### APPEAL SUMMARY

<b>Appeal ID:</b> 15366	<b>Project Address:</b> 4732 N Albina Ave
<b>Hearing Date:</b> 7/12/17	<b>Appellant Name:</b> Marissa Brown
<b>Case No.:</b> B-022	<b>Appellant Phone:</b> 503-235-9400
<b>Appeal Type:</b> Building	<b>Plans Examiner/Inspector:</b> Peter Drake
<b>Project Type:</b> commercial	<b>Stories:</b> 5 <b>Occupancy:</b> R-2, A-2, B, S, S-2 <b>Construction Type:</b> V-A over 1-A
<b>Building/Business Name:</b> Albina Apartments	<b>Fire Sprinklers:</b> Yes - All levels
<b>Appeal Involves:</b> Erection of a new structure	<b>LUR or Permit Application No.:</b> 17-112866-CO
<b>Plan Submitted Option:</b> pdf [File 1] [File 2] [File 3]	<b>Proposed use:</b> Multiple Family Residential

STAIR 2  
EGRESS  
APPEAL  
JOB #: 1531

ALBINA APARTMENTS

# GROUND FLOOR PLAN

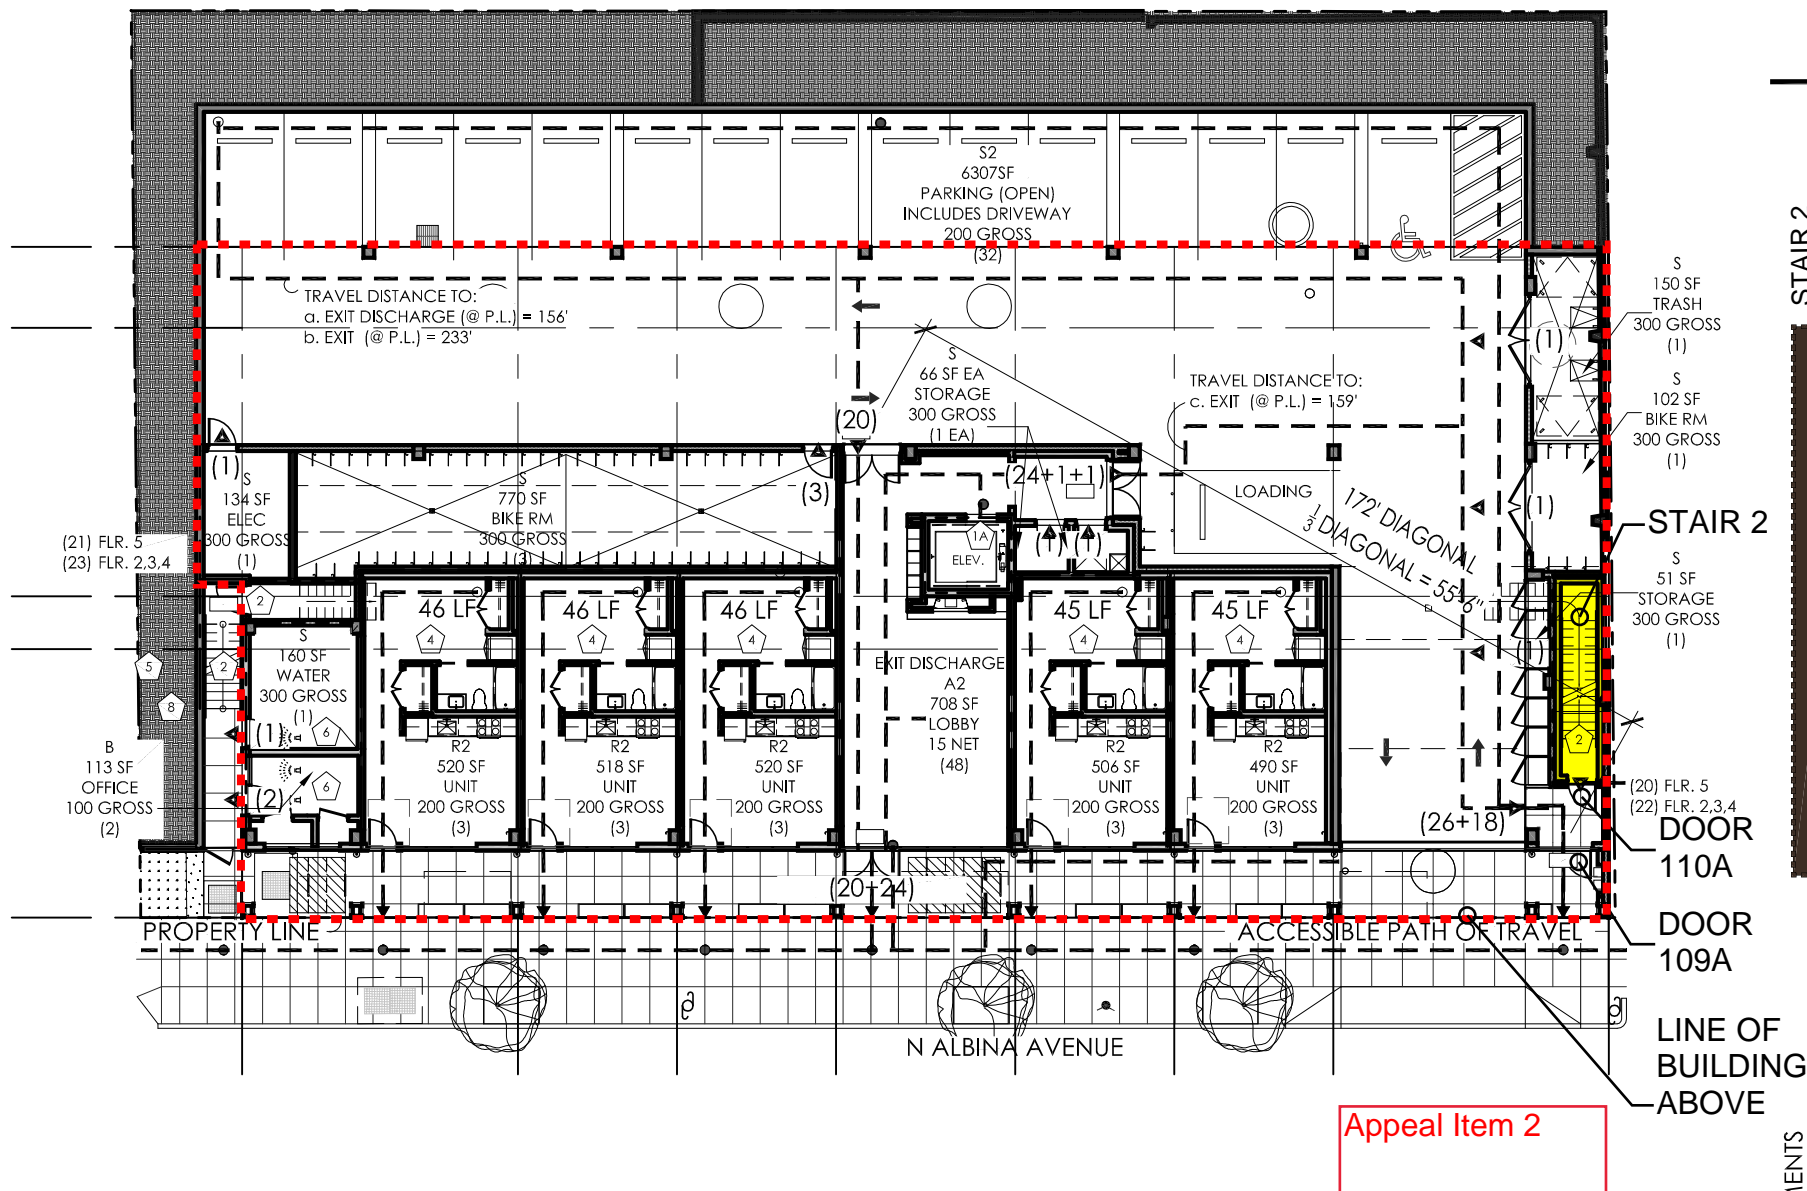
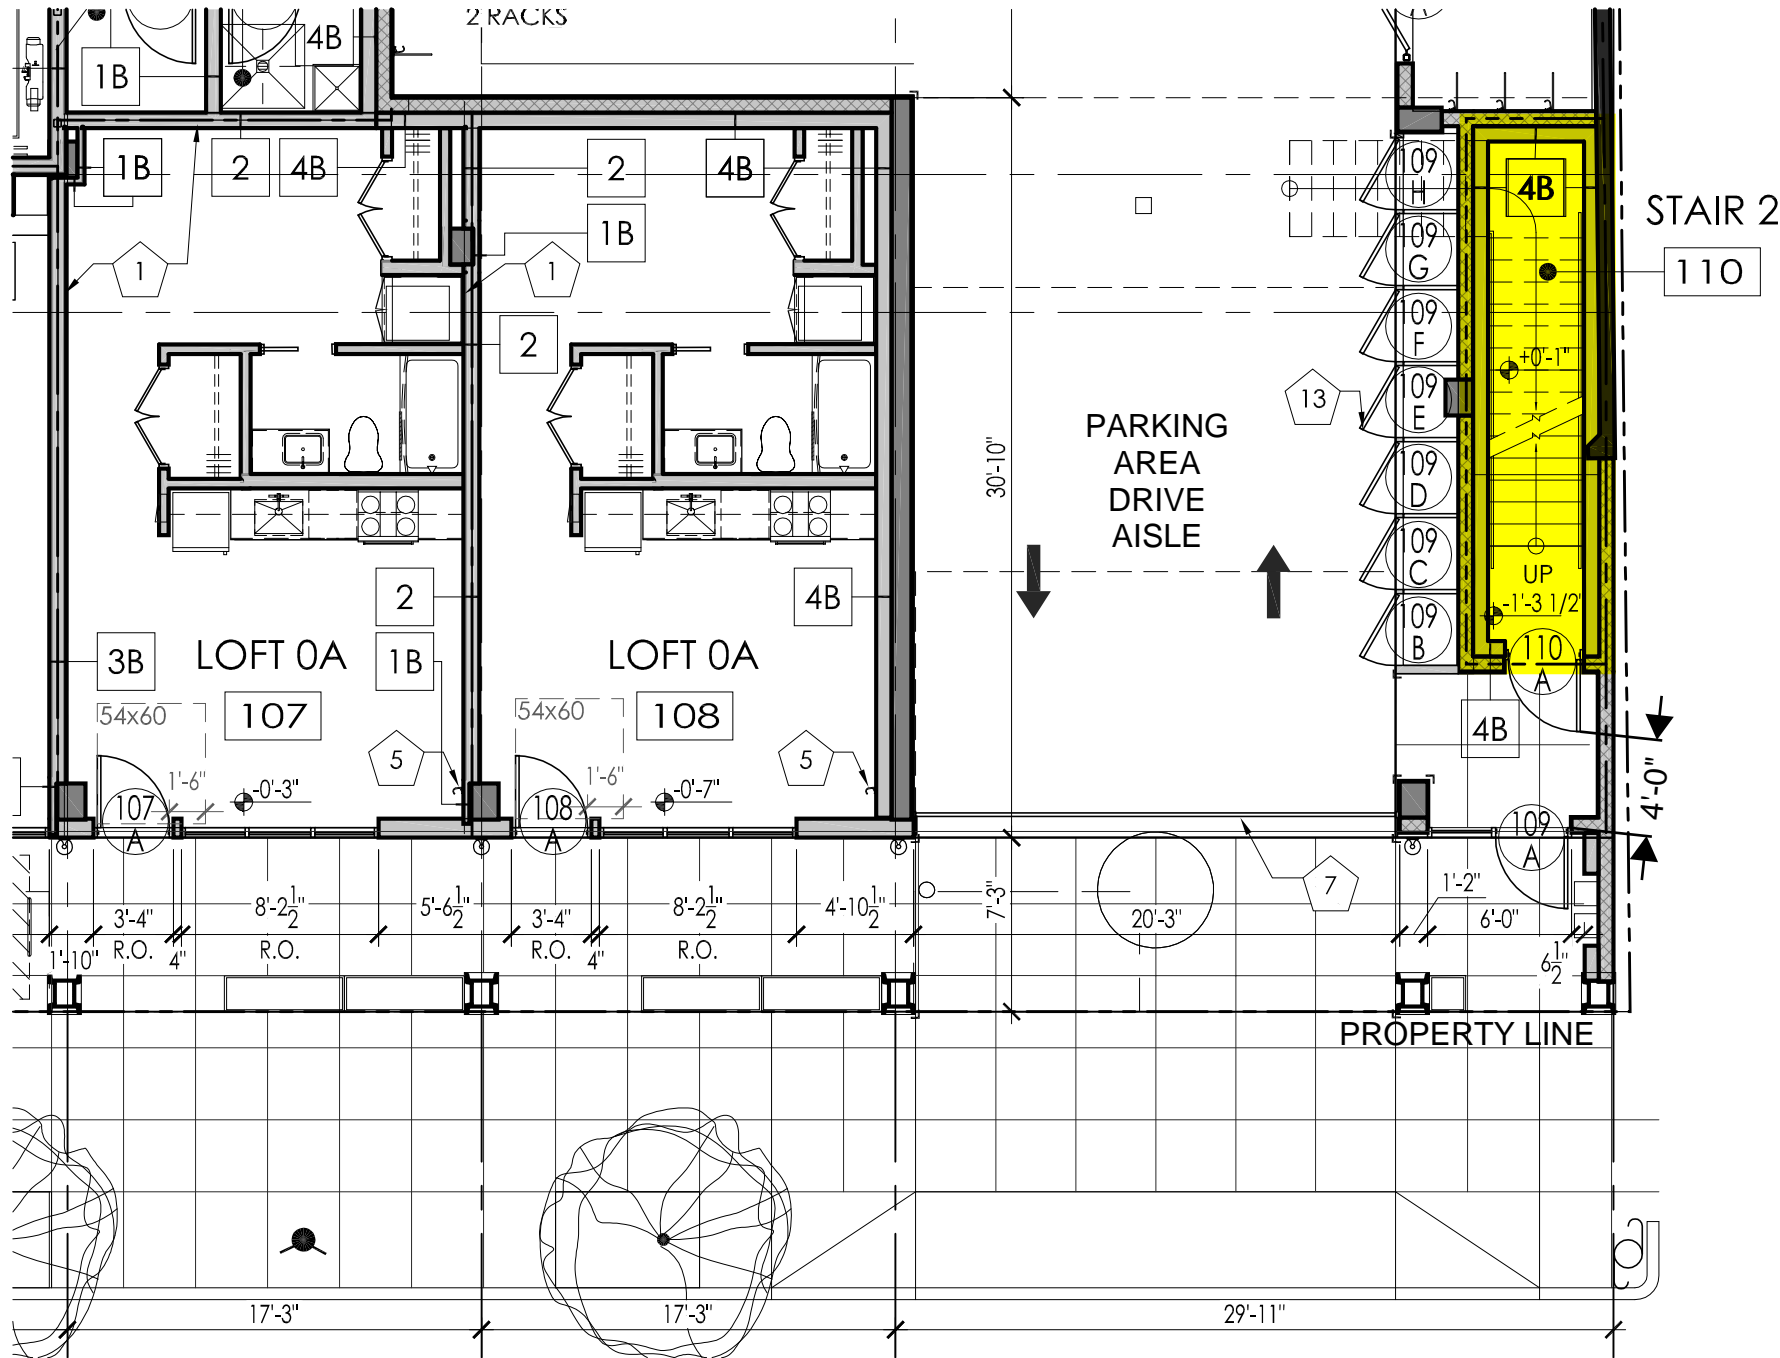
- 1022.1 Interior exit stairways and ramps shall lead directly to the exterior of the building or extend to the exterior of the building with an exit passageway conforming with Section 1023.
- 1023.4 Exit Passageways on the level of exit discharge shall terminate at an exit discharge.
- 1027.1 Exits shall discharge directly to the exterior of the building. Stair 2 exits into a vestibule before exiting into the public way. You may need to appeal this.

The proposed design for the exiting of 50% of occupants from levels 2 through 5 is by an Interior Exit Stairway of wood stair construction, labeled Stair 2, enclosed within a 2 hour fire barrier on levels 2-5 (Type VA), and enclosed within a 3 hour fire barrier on Ground Floor (Type 1A) after it penetrates the 2nd Floor 3-hour rated fire resistive floor assembly. The Exit Enclosure does not lead directly to the exterior of the building, nor is it extended to the exterior of the building with an exit passageway. We have not proposed a vestibule at the termination of Stair 2. We have proposed what is described in Exception 1 of Code Section 1027.1: Stair 2 exits into a covered, open-air parking area on the level of exit discharge (Ground Floor). The Stair 2 exit enclosure egresses through Door 110A to a free and unobstructed path of travel to an exterior exit door, Door 109A, which is readily visible and identifiable from the point of termination of the enclosure. The two doors are separated by the 48" minimum space between two doors in a series plus the width of the door swing of Door 110A. The egress path between door 110A and 109A continues straight, in same direction of travel as Stair 2. The ground floor is the lowest level of the building, there is no level below the level of exit discharge. The egress path in the covered parking area between doors 110A and 109A, as well as the covered open-air parking area, bike parking, trash/recycling area, and all other interior spaces on the Ground Floor (Type 1A) which may egress into the parking area, are proposed to be protected by an approved automatic sprinkler system.

bicycles, we prefer to avoid a vestibule or exit passageway which would require movement through two doors in a series in close proximity to pass between parking area and exterior of building. Door 110A (free egress) provides secured access to levels 2-5 for building tenants during times when the elevator is reserved for move-ins/move-outs. We prefer to leave this secured door within the parking area which requires key fob for access so that there are two points of secured access (at door 109A and door 110A before a person has access to residential floors 2-5). We believe the means of egress configuration described above meets requirements of Exception 1 of 1027.1, and request appeal of the Life Safety review checklist items listed above.

**2. Interior exit stair #2 discharge within building: Denied. Proposal does not provide equivalent Life Safety protection.**
